ADDENDUM

ADDENDUM NO.: 04
PROJECT NAME: Salt Dome Replacement Facility (Grand Avenue)
PROJECT NO.: 04021
CONTRACT NO.: C1598
DATE OF ISSUE: January 27, 2021

NOTICE OF CHANGES, MODIFICATIONS, OR CLARIFICATIONS TO CONTRACT DOCUMENTS

Sheet
AS1.1

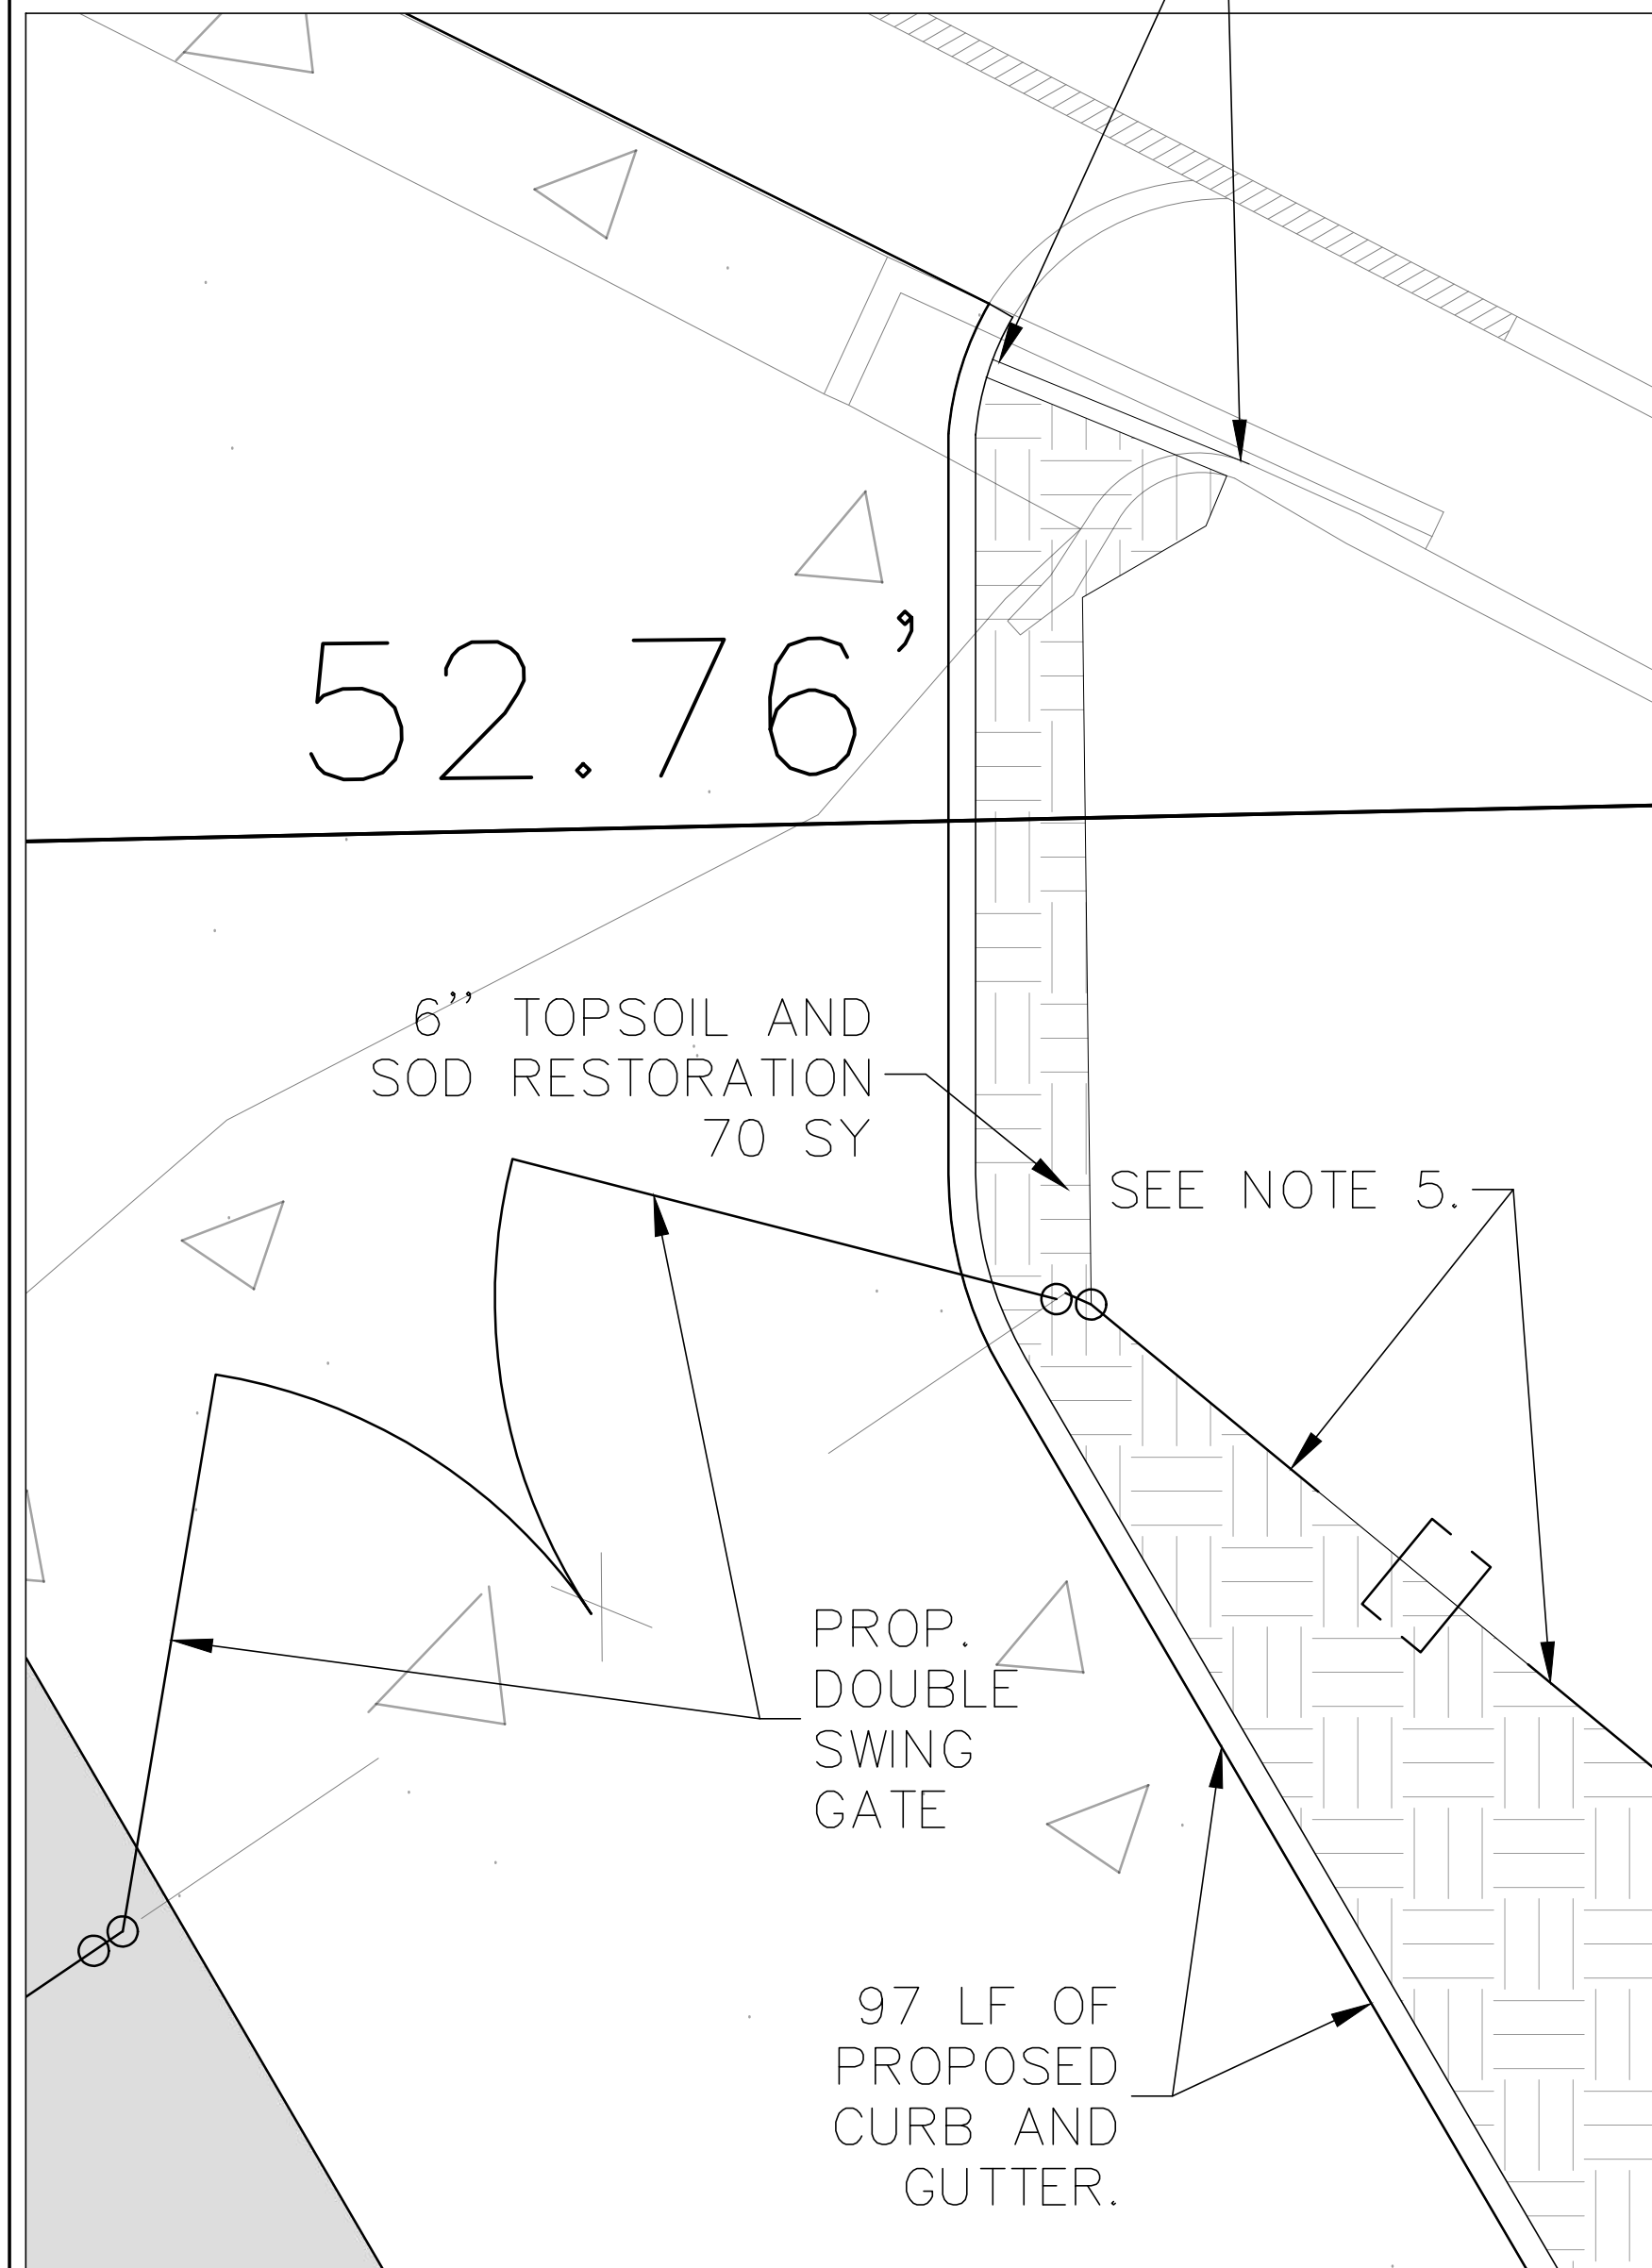
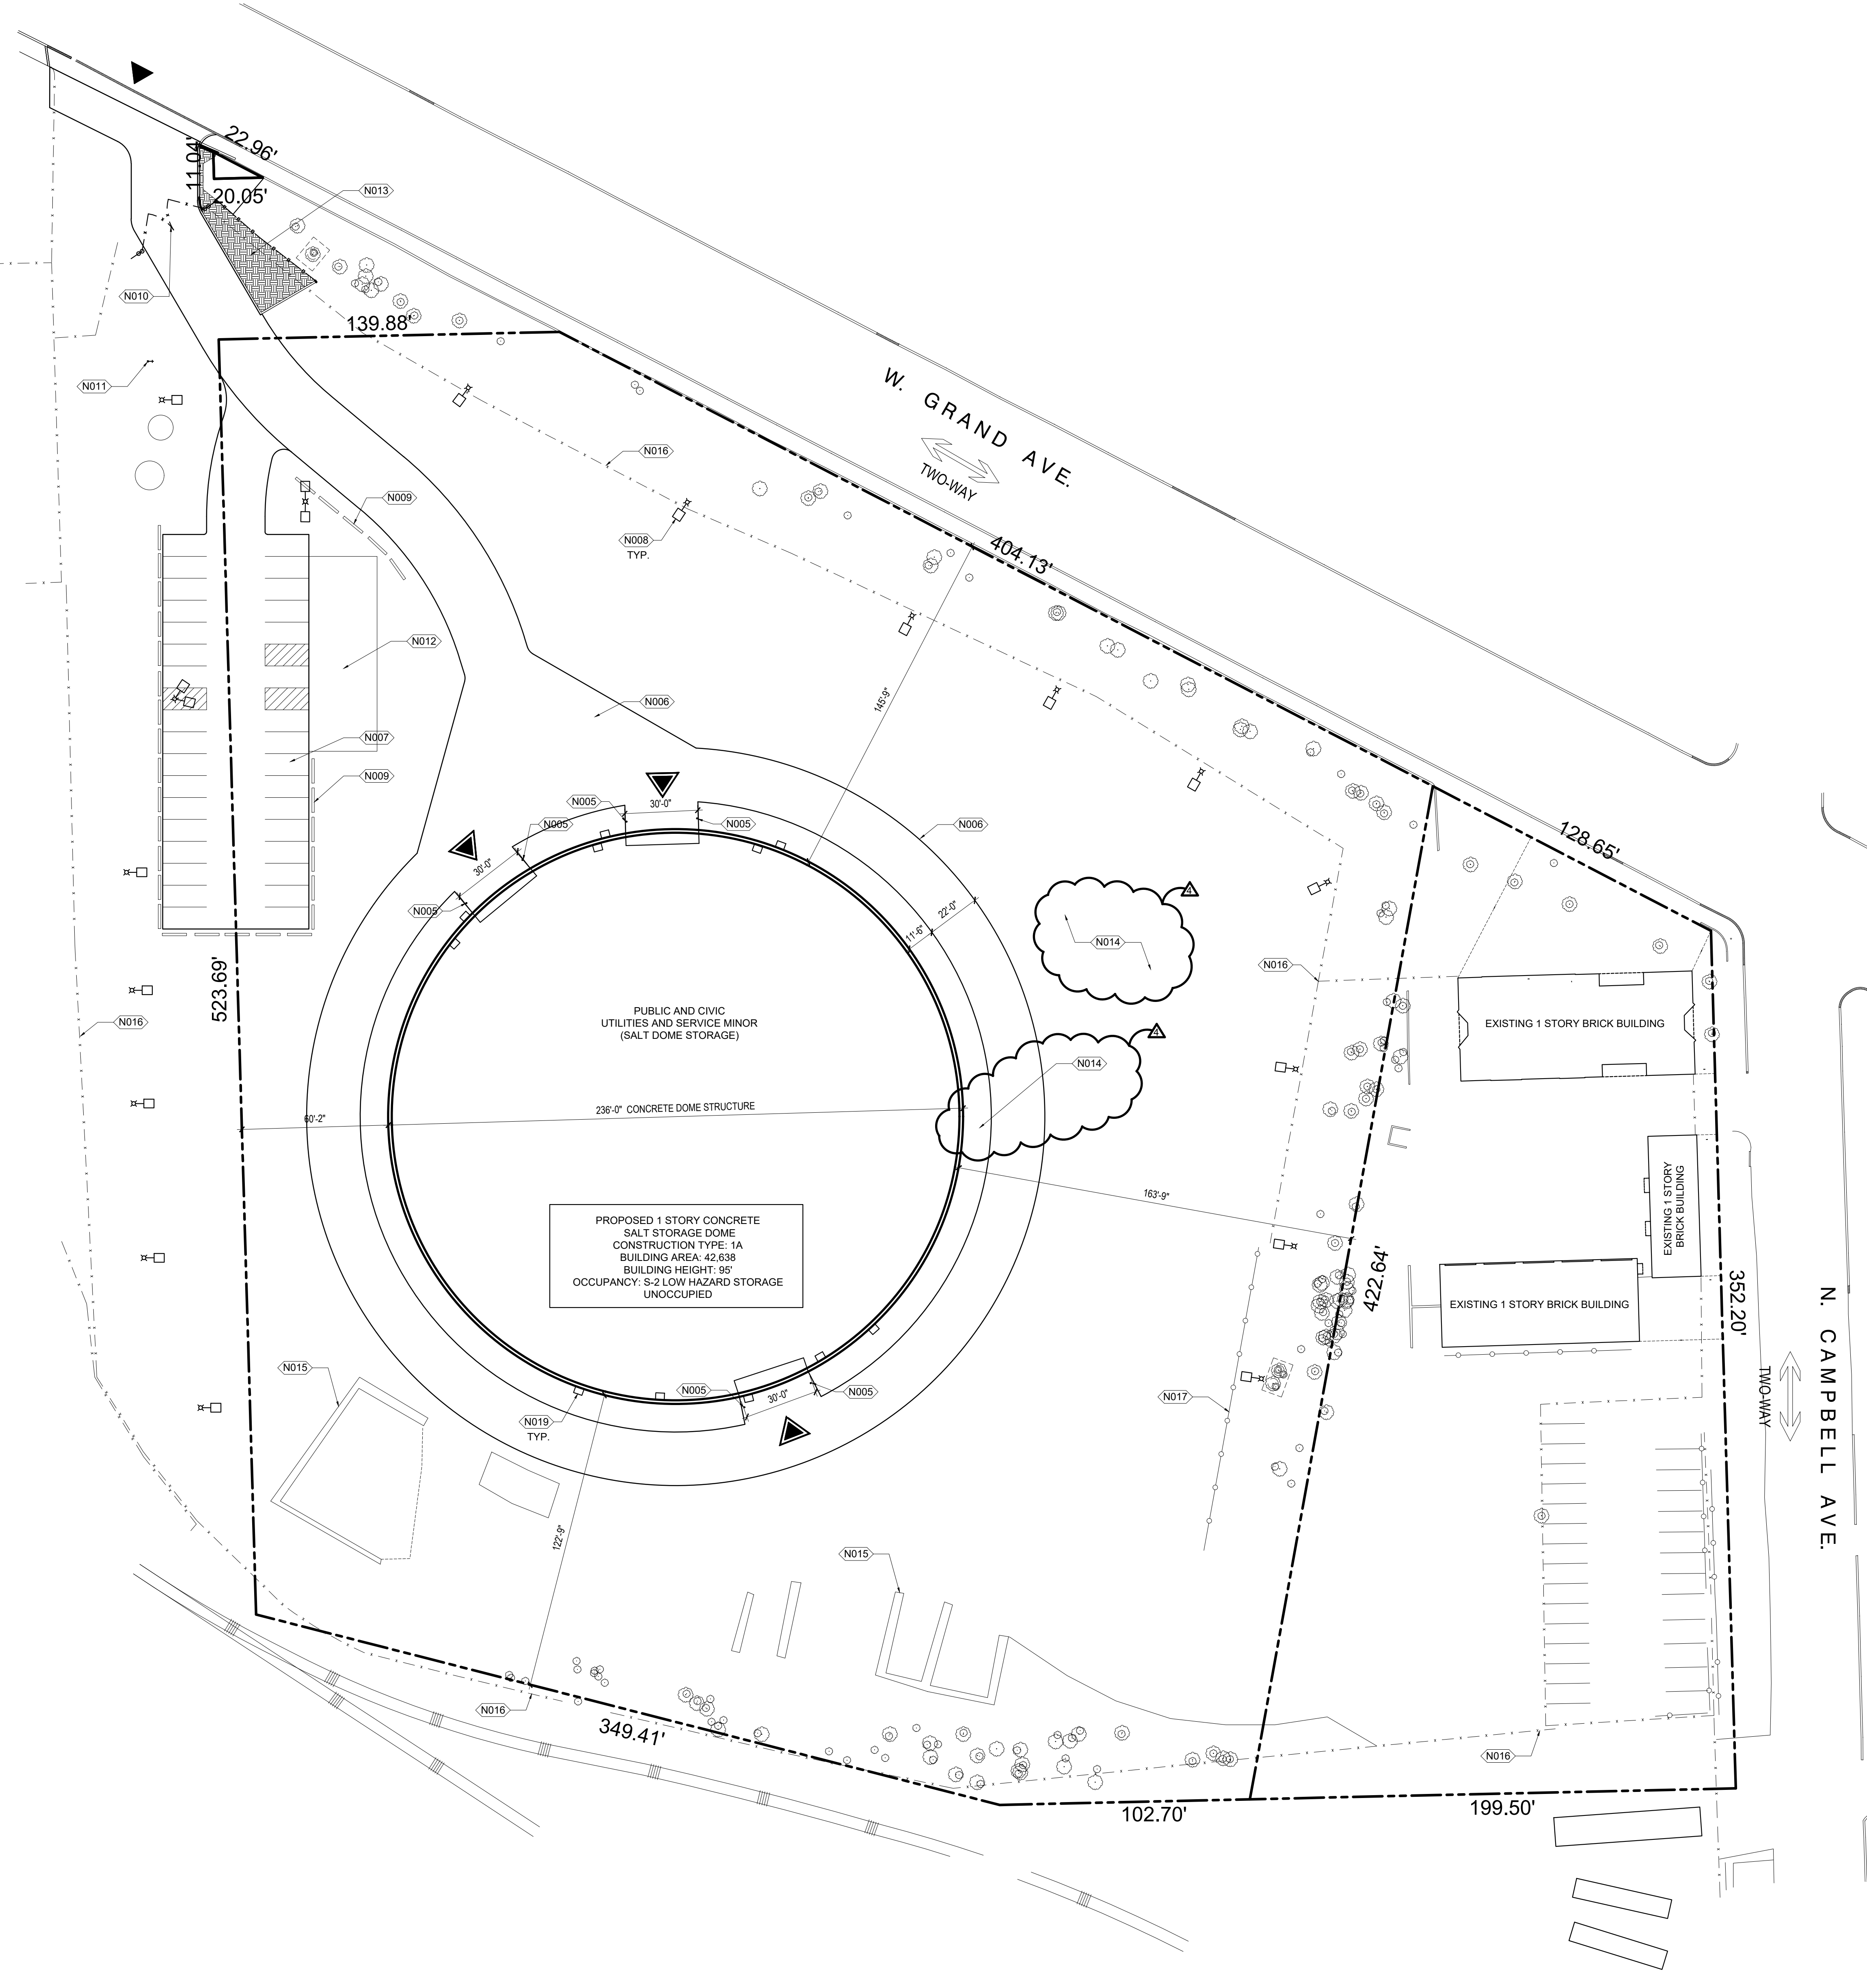
Change 1 **REVISED** Drawing No. AS1.1, Site Plan: Keynote N014 revised to clarify surface material. Surface material adjacent to dome revised to match civil drawings.

Response: Confirmed. The jersey barricades identified on Drawing Sheet AS1.1 are the same as indicated on Drawing Sheet C1.2.

Response: Drawing Sheet C1.2, C1.2A, and AS1.1 have been revised to show the scope of Work. The proposed surface between the dome and the ring road shall be a 6" minimum thickness layer of CA-6.

Response: Revised Drawing sheet C1.2, C1.2A and AS1.1, have been revised and included in this Addendum. The Contractor should assume that the typical surface outside of paved areas is a minimum of 6" of CA-6. Where existing asphalt milling surface exceeds 3" and is undisturbed it may be left in place.
